AGENDA
CONCEPTUAL PLAN REVIEW COMMITTEE
Community Room, 3rd Floor
Arlington Heights Village Hall, 33 S. Arlington Heights Rd.
Arlington Heights IL 60005
February 12, 2025
6:00 PM

VILLAGE OF ARLINGTON HEIGHTS
STAFF DEVELOPMENT
COMMITTEE REPORT

Temp File Number: T1852
Project Title: 770 W Dundee Rd.
Address: 770 W. Dundee Rd.
PIN: 03-06-400-048, 03-06-400-052

VILLAGE OF ARLINGTON HEIGHTS **STAFF DEVELOPMENT** **COMMITTEE REPORT**

1 PRELIMINARY FIRST FLOOR PLAN
SCALE: NTS

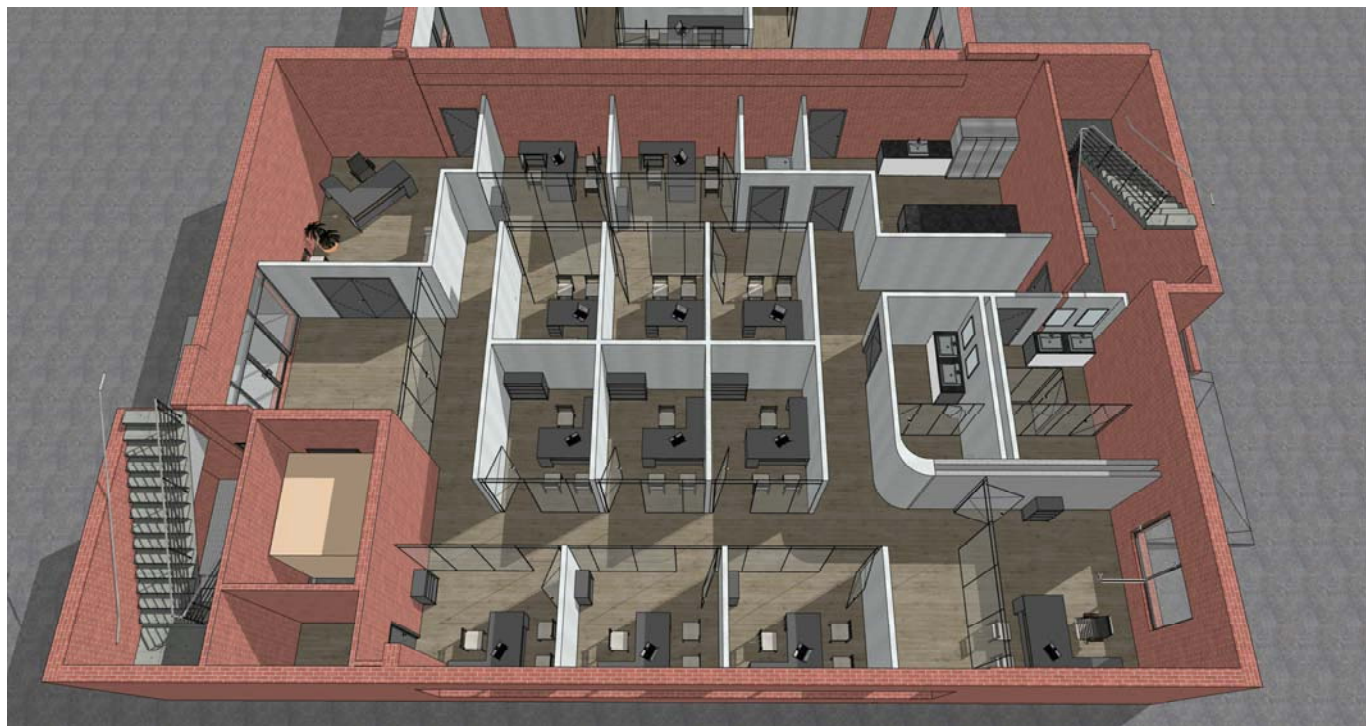
8. An additional restroom may be required per the Illinois Plumbing Code to provide additional separate men's and women's facilities for the existing for the existing occupant load. Provide a plumbing fixture count analysis. The plans do not appear to conform to this requirement.

9. Provide an accessible sink and accessible seating for the break room kitchen. Information was not provided.

11. Provide the width of the corridors in office. Information was not provided.
